LAND USE SERVICES DEPARTMENT
PLANNING COMMISSION STAFF REPORT

HEARING DATE: November 3, 2016 **AGENDA ITEM # 2**

Project Description: General Plan Renewable Energy and Conservation Element

Applicant:	Land Use Services Department
Community:	Countywide
Location:	Countywide
Staff:	Linda Mawby, Senior Planner
Proposal:	General Plan Amendment to incorporate a new Renewable Energy and Conservation Element.

Figure 4. Desert Linkage Network Conflicts in the Pinto Lucerne Valley Eastern Slopes Ecoregion Subarea

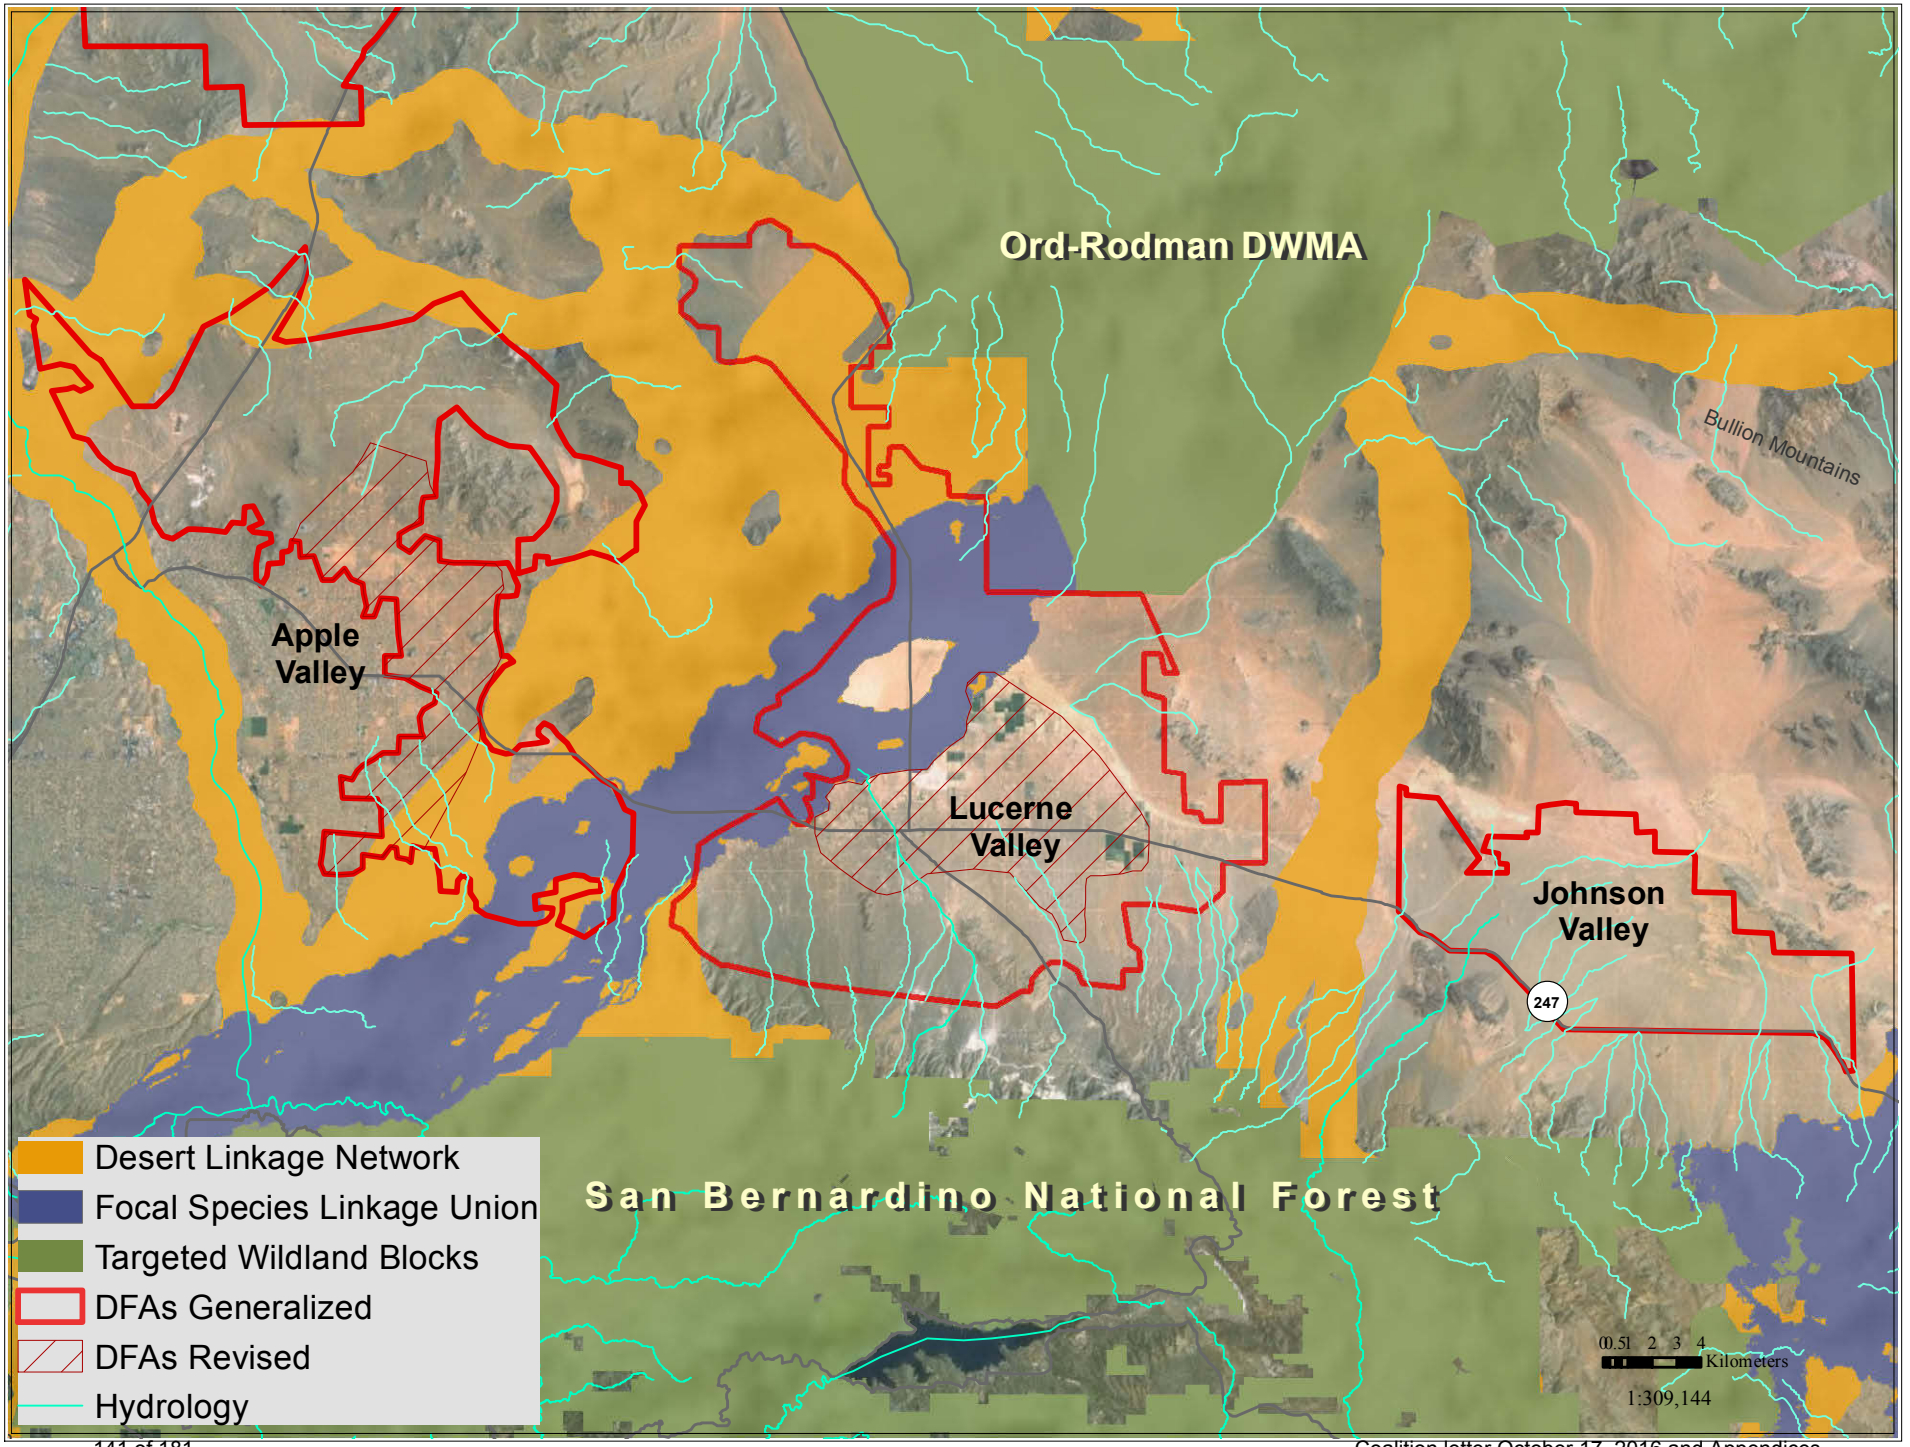
The Twentynine Palms Newberry Rodman-San Gabriel Connection and the Twentynine Palms Newberry Rodman-San Bernardino Connection of the Desert Linkage Network (Penrod et al. 2012) overlap one another in the area of the proposed Apple Valley and Lucerne Valley DFAs. Figure 4 of the Desert Linkage Network in this region also includes the Focal Species Linkage Union (blue) to show the area of the linkage network that was delineated by the land facet analyses (orange). The Proposed Granite Mountain Wildlife Linkage ACEC was designed to connect SBNF with the Bendire's Thrasher ACEC, while the Northern Lucerne Wildlife Linkage is expected to connect the Bendire's Thrasher ACEC to Ord-Rodman DWMA. As proposed, the Granite Mountain Wildlife Linkage ACEC is reduced to about 1.2 miles wide for much of its length south of State Route 18 and more closely follows the linkage design for the San Bernardino-Granite Connection (Penrod et al. 2005), which did not include land facet analyses. Several land facets corridors were delineated between these ranges (see Figures 18 and 19 in Penrod et al. 2012), which are expected to support species movements during periods of climate instability. DFAs are proposed to either side of these proposed ACECs that would constrain the linkage for a distance of roughly 20 miles. Species are then expected to make a hard right to follow Stoddard Ridge around the arm of the DFA proposed in the Northern Lucerne Valley. Objective L1.2 is to "Design landscape linkage corridors to be 3 miles wide where feasible, and at least 1.2 miles wide where a greater width is not feasible". We believe that a greater width is feasible and desirable for the proposed Granite Mountain Wildlife Linkage ACEC. No DFAs should be sited within these areas.

Figure 5. Bighorn Sheep Conflicts in the Pinto Lucerne Valley Eastern Slopes Ecoregion Subarea

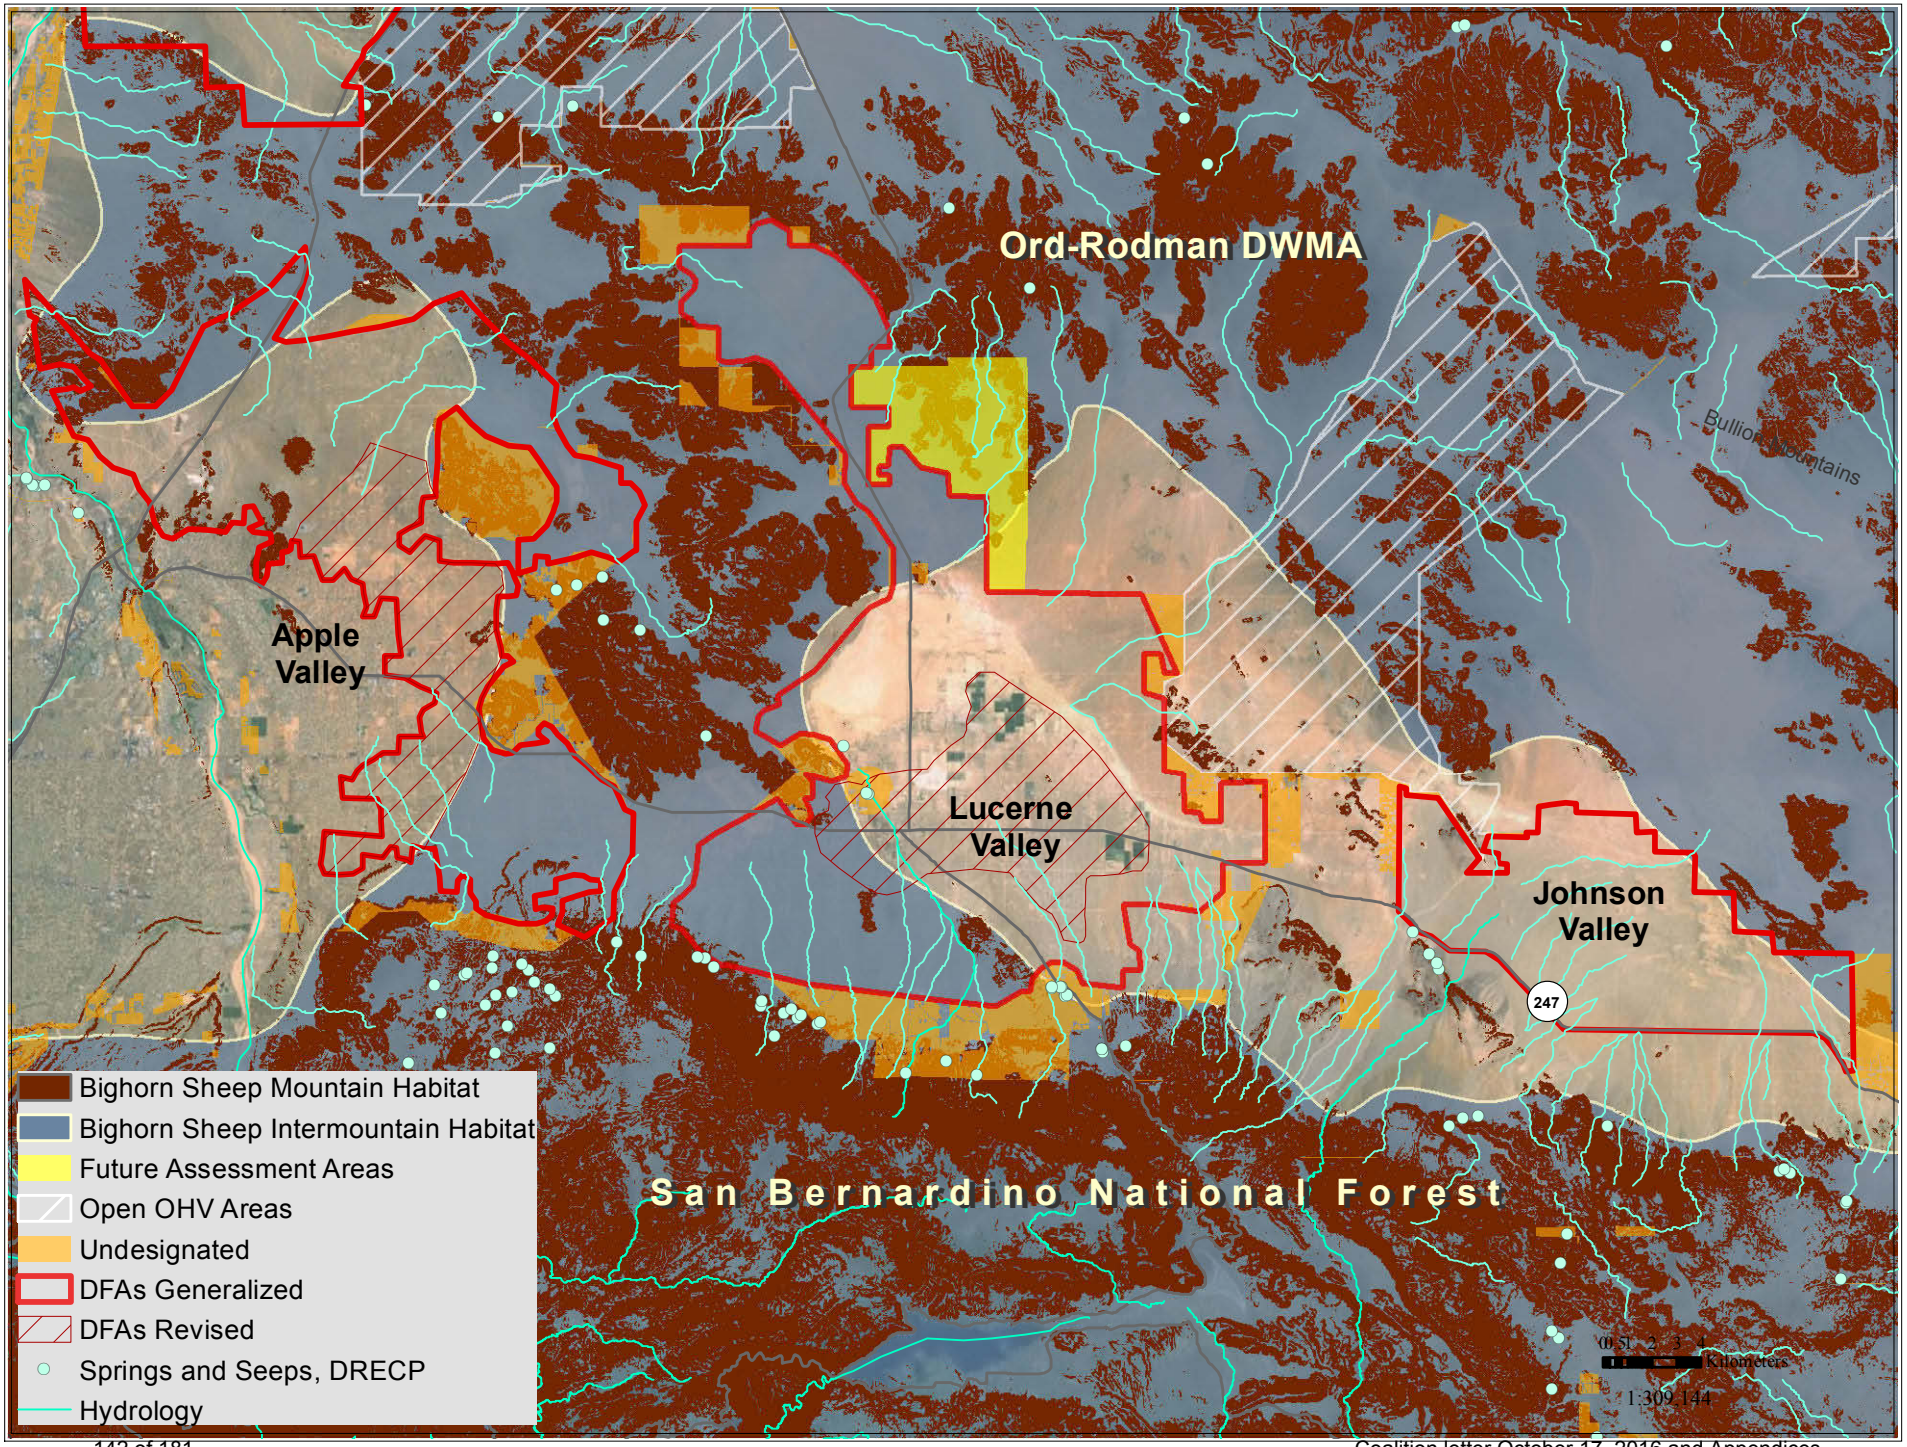
Figure 5 depicts Desert Bighorn Sheep - Intermountain & Unfiltered Core Habitat (California Department of Fish and Wildlife, April 2013 Draft, A Conservation Plan for Desert Bighorn Sheep in California) in relation to the Preferred Alternative in this subarea. The Desert Bighorn Sheep Mountain Habitat identifies historic, current, and potential core habitat, while the Intermountain Habitat represents the intermountain, lower slope, valley bottom habitat used by desert bighorn sheep to move between mountain habitat. CDFW, also the lead agency on the NCCP, mapped an intermountain connection between San Bernardino National Forest (SBNF) and Ord-Rodman that has a minimum width of roughly 7.8 miles. Bighorn sheep mountain habitat and intermountain habitat largely overlap with the Desert Linkage Network. The upper arm of the Lucerne Valley DFA disrupts intermountain bighorn habitat and should be

reconfigured. Further the FAA includes bighorn sheep mountain habitat in close proximity to mountain habitat in the Granite Mountain Linkage and should be included in the Newberry Rodman ACEC and NLCS. Finally, several areas of bighorn sheep mountain habitat are identified as Undesignated and available for "disposal". Bighorn mountain habitat along the perimeter of the proposed Granite Mountain and Northern Lucerne Wildlife Linkage ACECs should be included in the Reserve Design. Further, Undesignated land on the Ridgeline and slopes of the San Bernardino Mountains between the Juniper Flats NLCS and the Carbonate Endemic Plants NLCS (roughly 15 additional miles is the Grapevine Canyon Recreation Area also known as Juniper Flats by the BLM) should also be included in the Reserve Design, consistent with Step-Down Biological Objective DBSH-B and because there are many springs, seeps, significant riparian canyons, alluvial fans (i.e. rare piedmont fans), and washes in this area essential for bighorn sheep and numerous other species. This area is currently designated as Undesignated in the Preferred Alternative.

Figure 6. High Value Desert Tortoise Habitat in the Pinto Lucerne Valley Eastern Slopes (Nussear et al. 2009)

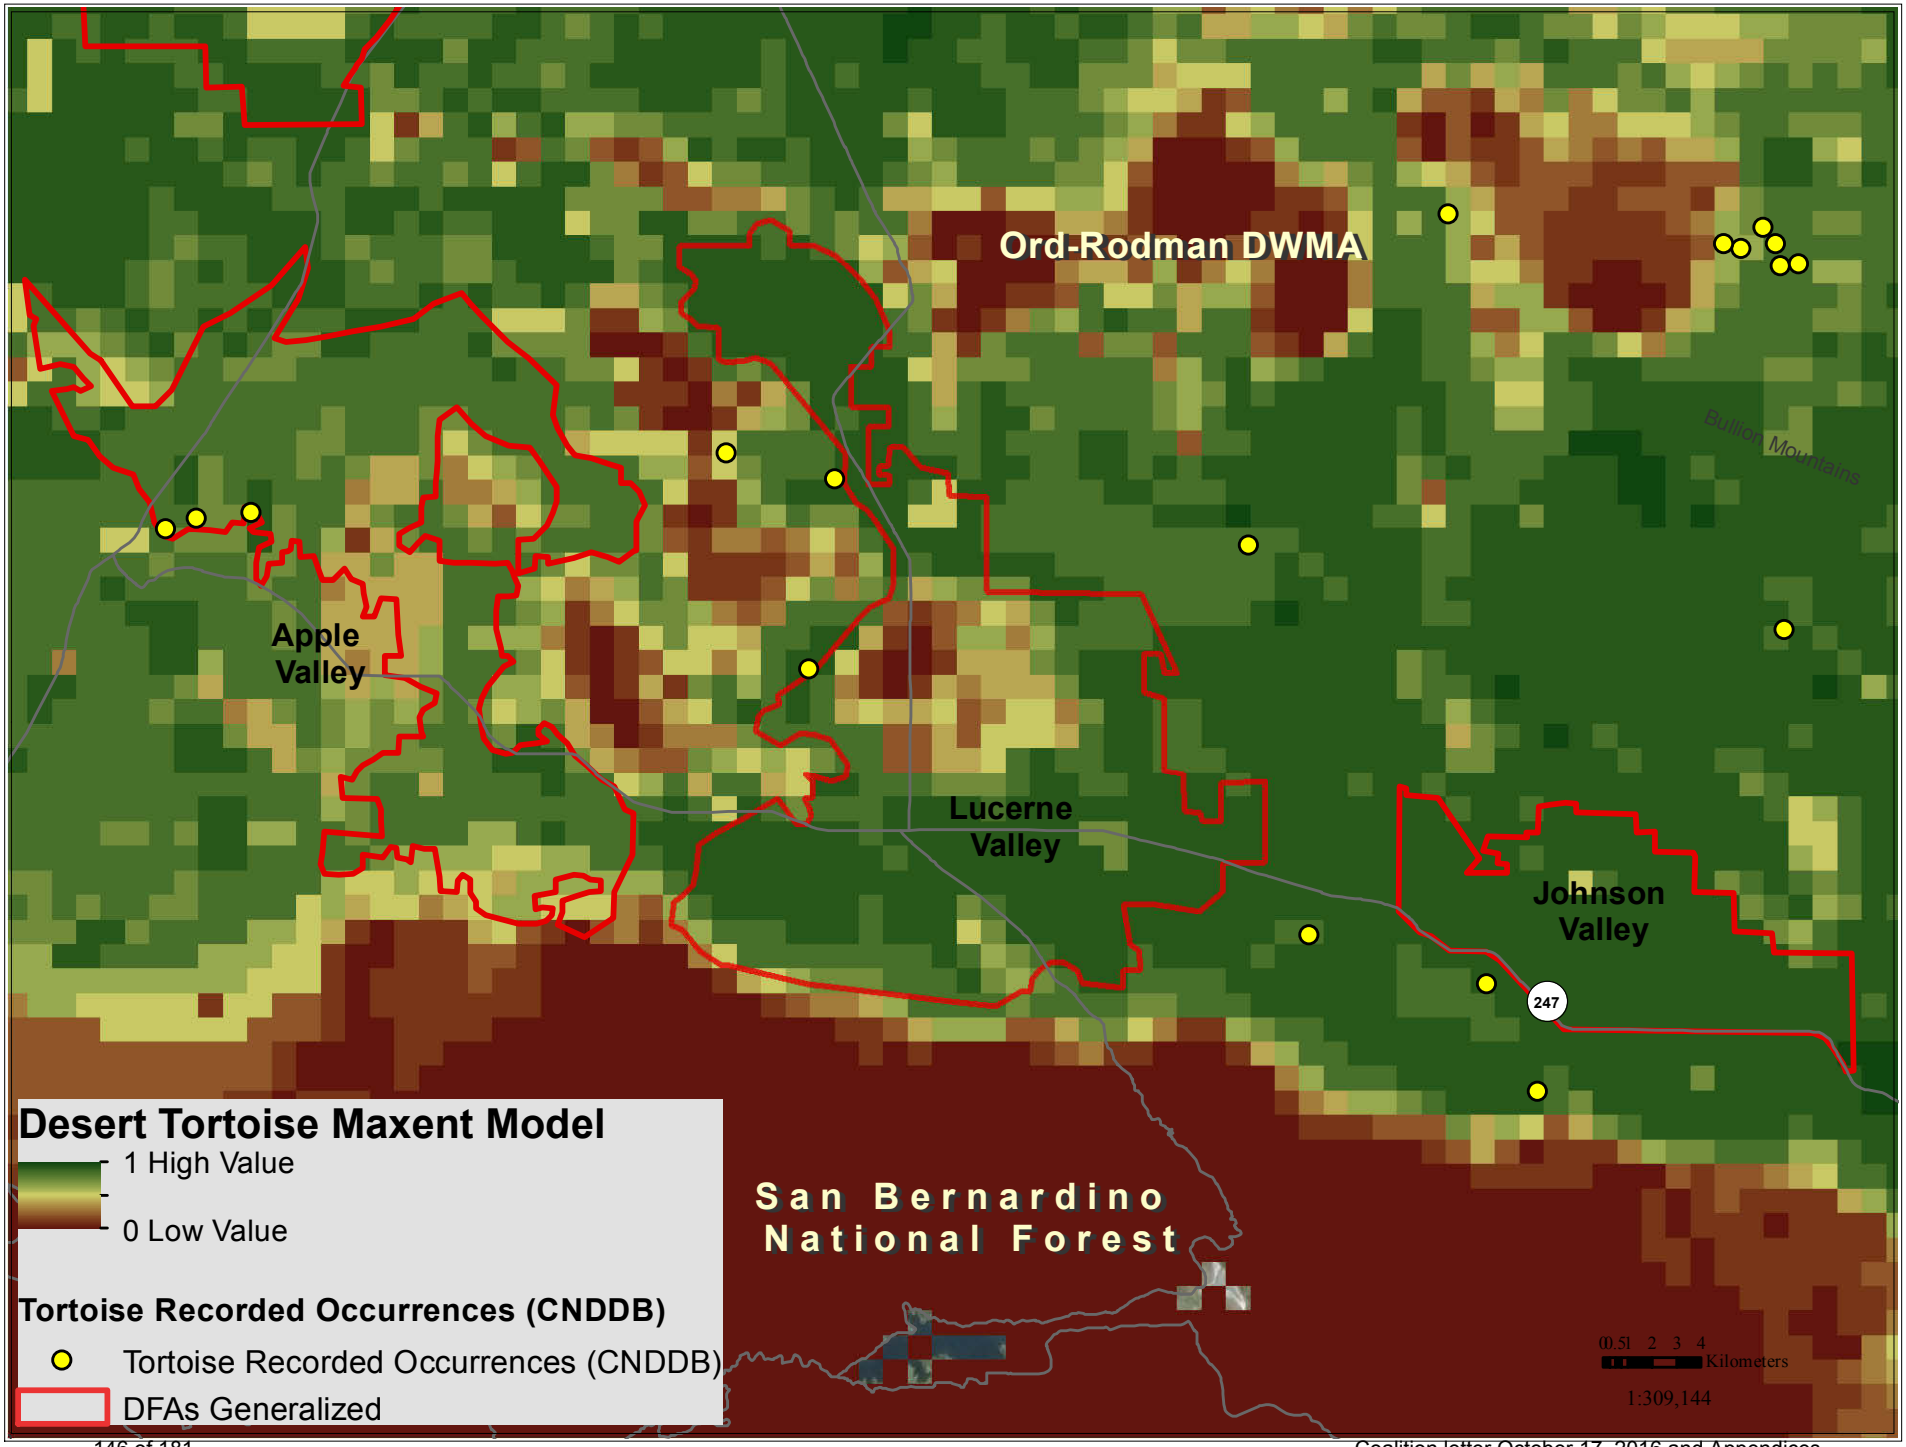
It is Nussear et al. 2009, not 2001. Nussear et al. (2009) identifies much of the Apple Valley, Lucerne Valley and Johnson Valley DFAs as highly suitable habitat for tortoise (Figure 6).
